Memorandum

Date: April 16, 2012
Telephone: (916) 654-4894
File: 11-AFC-2

Subject: **HIDDEN HILLS SOLAR ELECTRIC GENERATING SYSTEM (11-AFC-2)**
STATUS REPORT #4

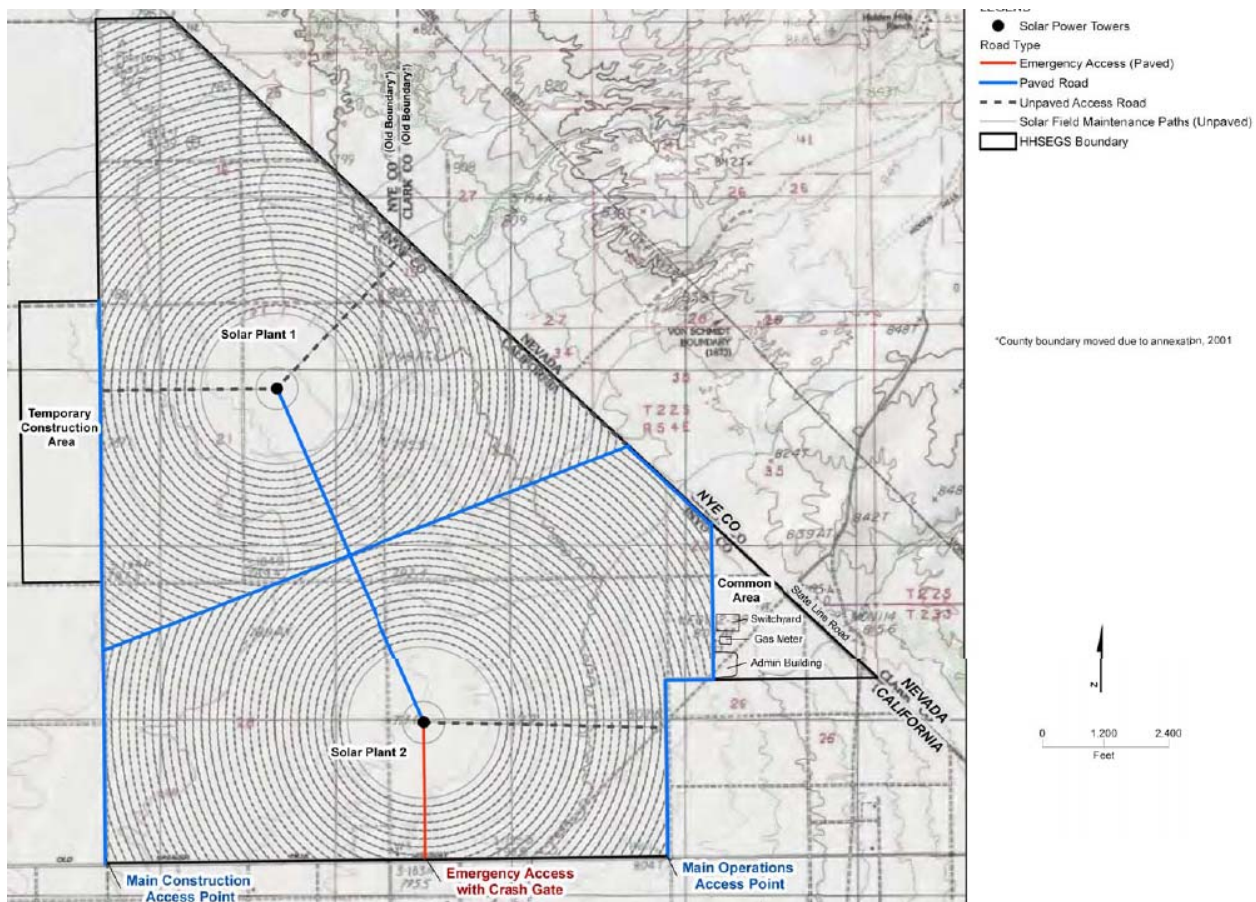
On April 2, 2012, Applicant filed its Boiler Optimization (Design Change) Plan. The Design Change would move the 230kV onsite switchyard and natural gas meter station from the Common Area (depicted below in AFC Figure 3.2-1) east into an undisclosed, offsite area in Nevada. While the change in location of the switchyard is reported to be attributable to new direction the applicant received from the Bureau of Land Management regarding offsite transmission linears, several new issues have arisen that will now need to be resolved by staff. The Applicant indicated in its April 2, 2012 filing that no significant impacts would result from the Design Change in any technical area (and in fact would be reduced in the area of Visual Resources given the elimination of above-ground transmission poles). However, staff is nonetheless concerned and seeks to resolve questions in several areas, including:

Biological Resources / Soil Resources: will the trenching required to underground transmission lines from Solar Field 1 and Solar Field 2 transect key ephemeral washes that constitute state and federal waters (especially along the California/Nevada border)?

Traffic and Transportation: will the new undergrounded transmission configuration From both Solar Plant 1 and Solar Plant 2 necessitate new or additional roads?

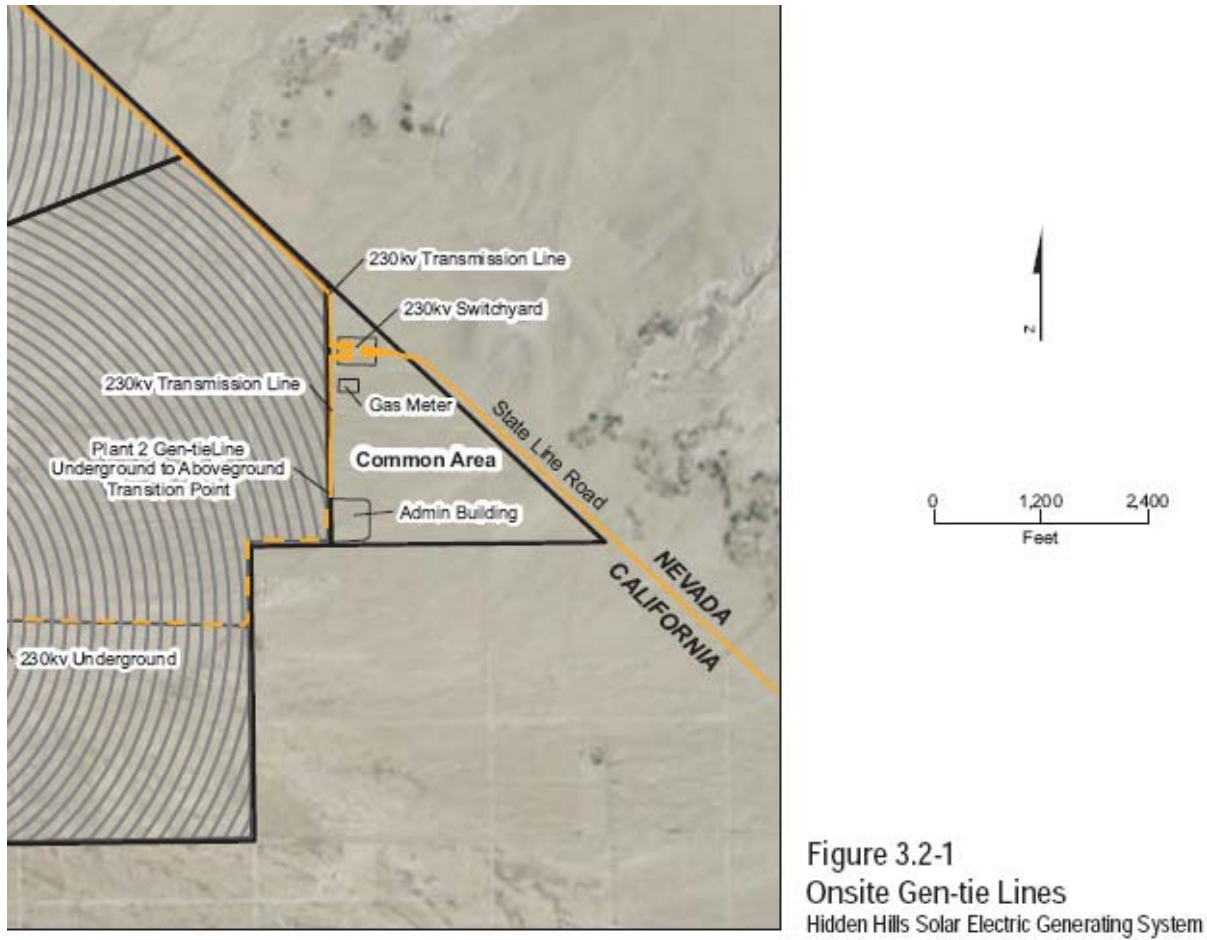
Transmission System Engineering: Absent a revised one-line diagram and a revised switchyard configuration, will key Phase II study findings/recommendations from the CAISO need to be revised? For your information, AFC Figure 3.2-1 (below) depicts the originally-proposed location of the 230 kV Switchyard and 230kV Transmission Lines.
